DATE: 08-21-25
DESCRIPTION: HVAC FIELD CHANGES
REVISIONS: 1

NEW WAREHOUSES
J & Y INVESTMENTS LLC
429 SOUTH STREET
SLIDELL, LA 70460
JOB NO: 2449
DATE: 08-21-2025
DRAWN BY: LJP
CHECKED BY: CJK

SHEET TITLE: MECHANICAL PLAN
DRAWING NUMBER: **M101**
SHEET No: 9 of 12

MECHANICAL PLAN
SCALE: 3/16"=1'-0"

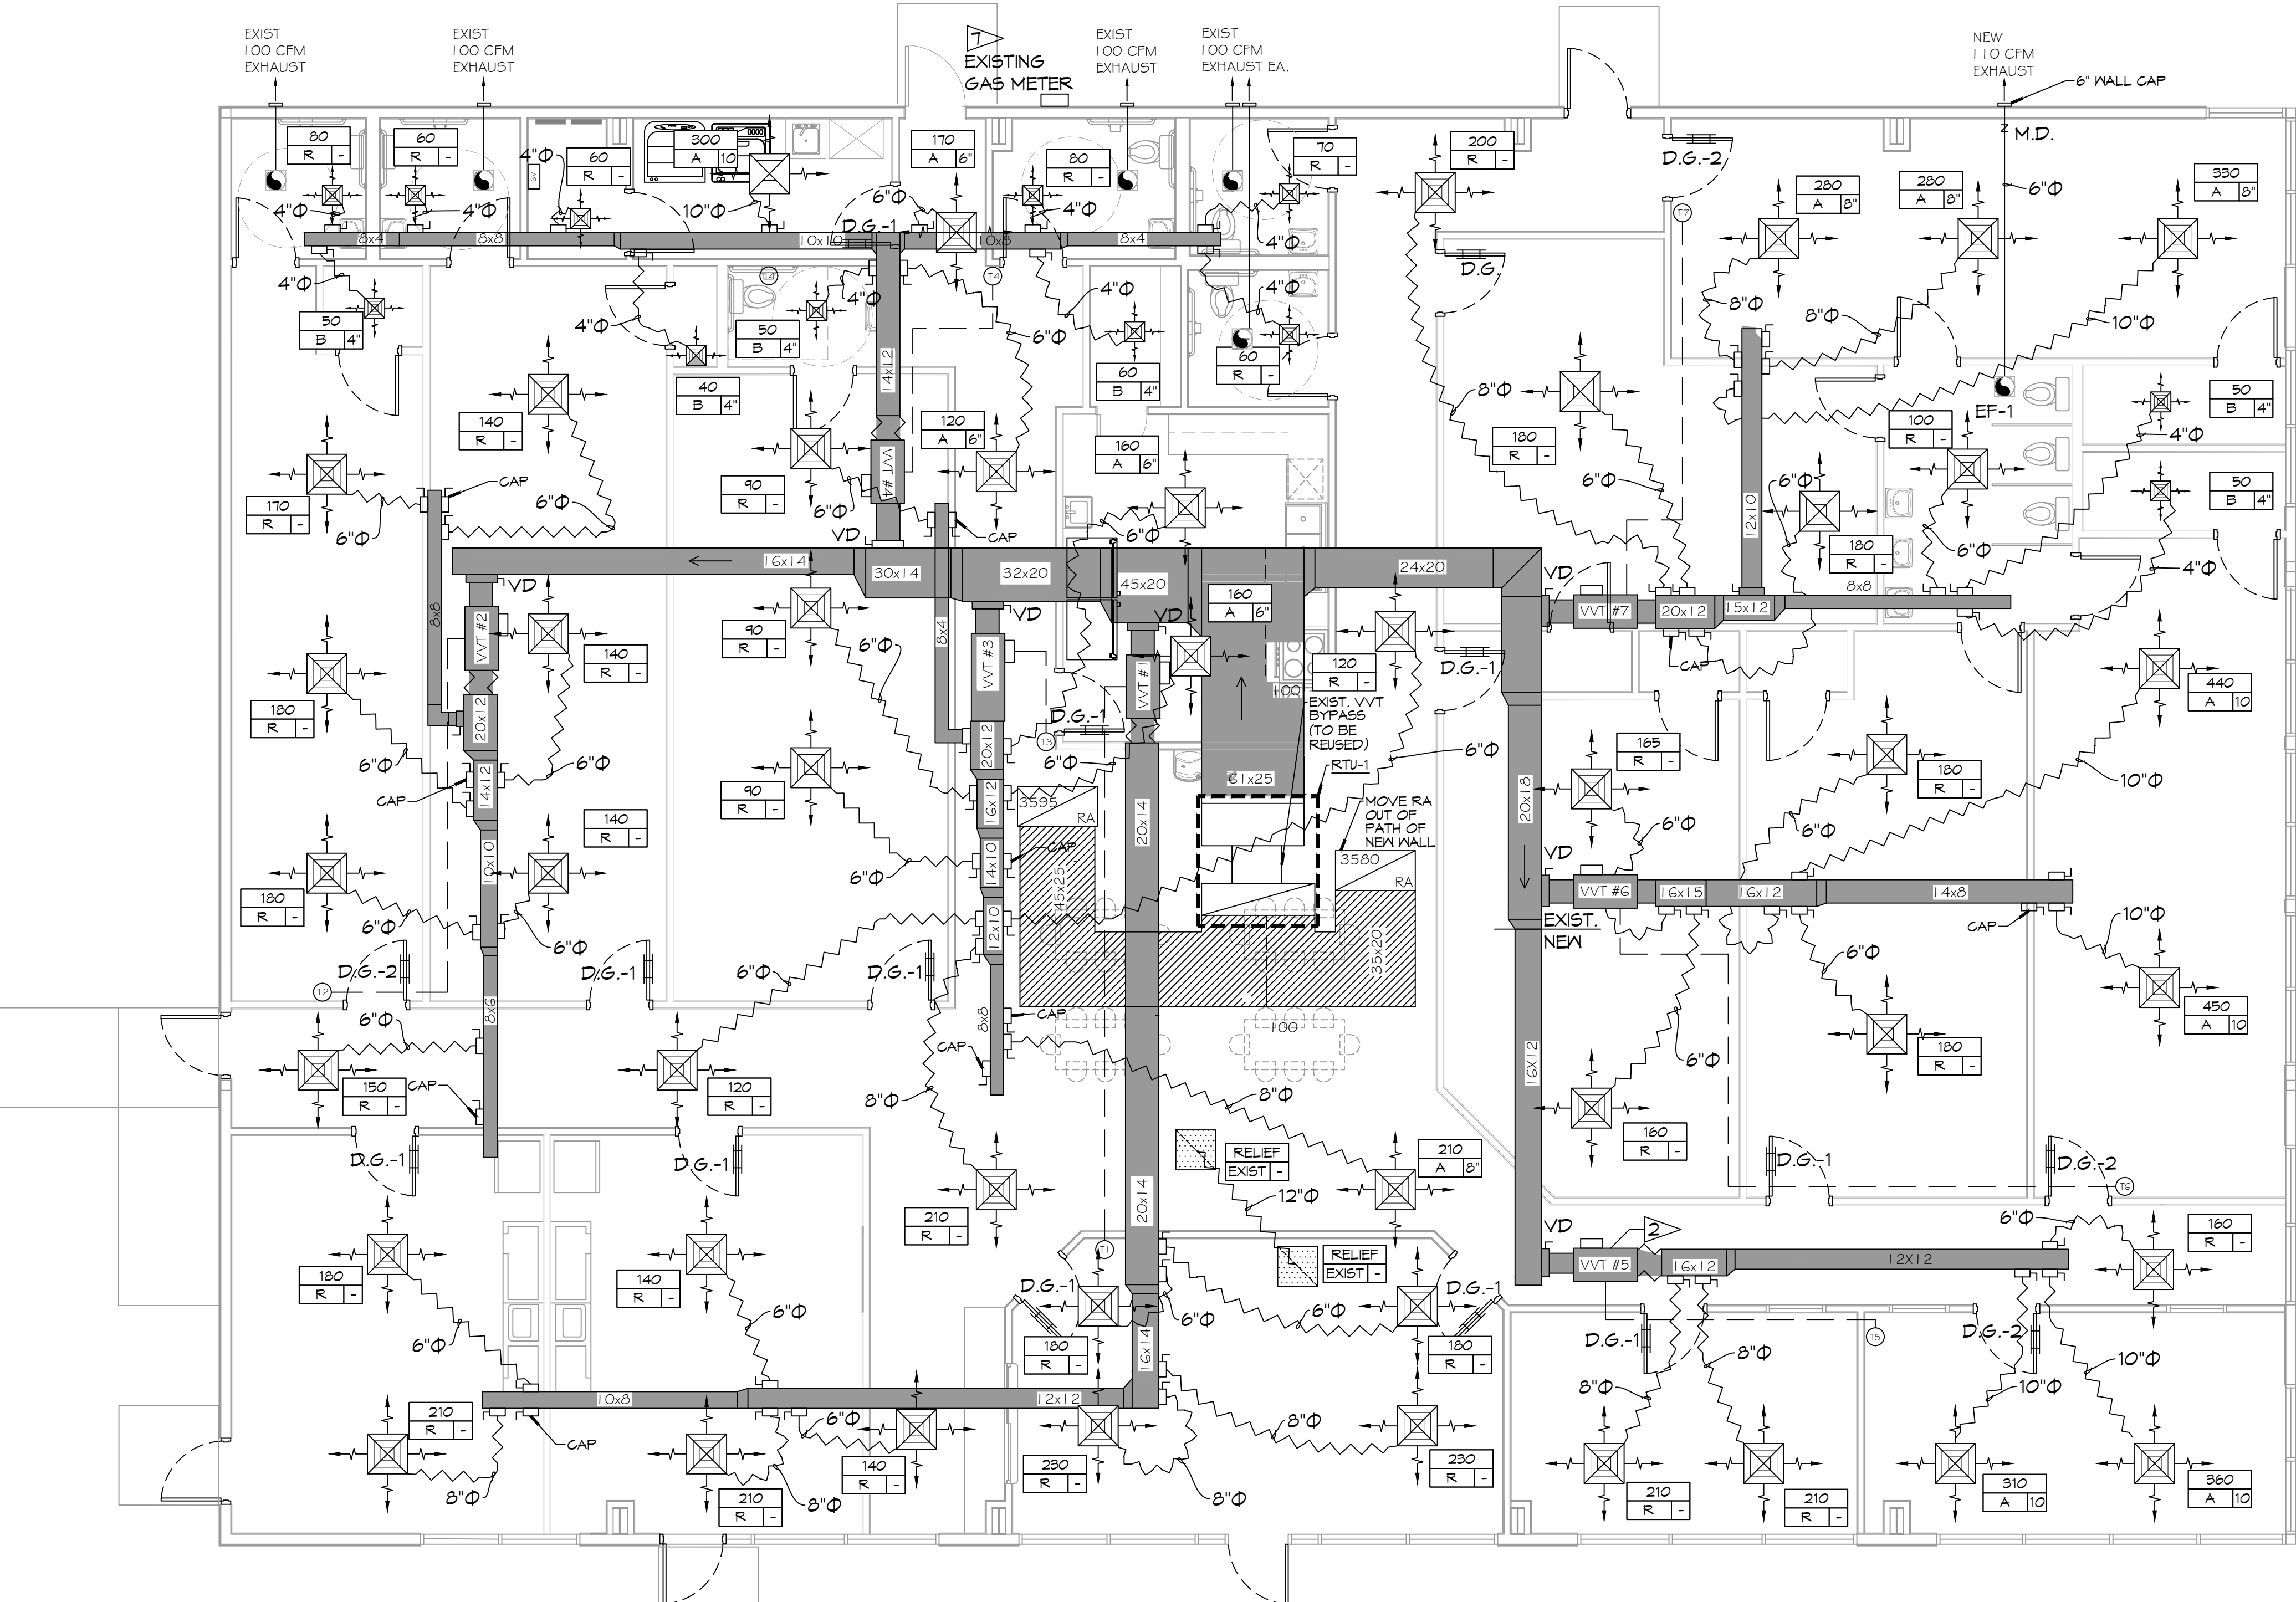
- VERIFY HVAC CONTROLS AND COMPONENTS ARE COMPLETE AND FUNCTIONAL.
- REPLACE VAV #5 VAV BOX (REFERENCE SCHEDULE)
- RELOCATE/ REPLACE DIFFUSERS AS NOTED (REFERENCE SCHEDULE)
- MODIFY DUCTWORK AS NOTED.
- REPLACE RTU-1 (REFERENCE SCHEDULE)
- BALANCE AIRFLOWS AS NEEDED.
- REUSE EXISTING ??? SUPPLY TO RTU-1
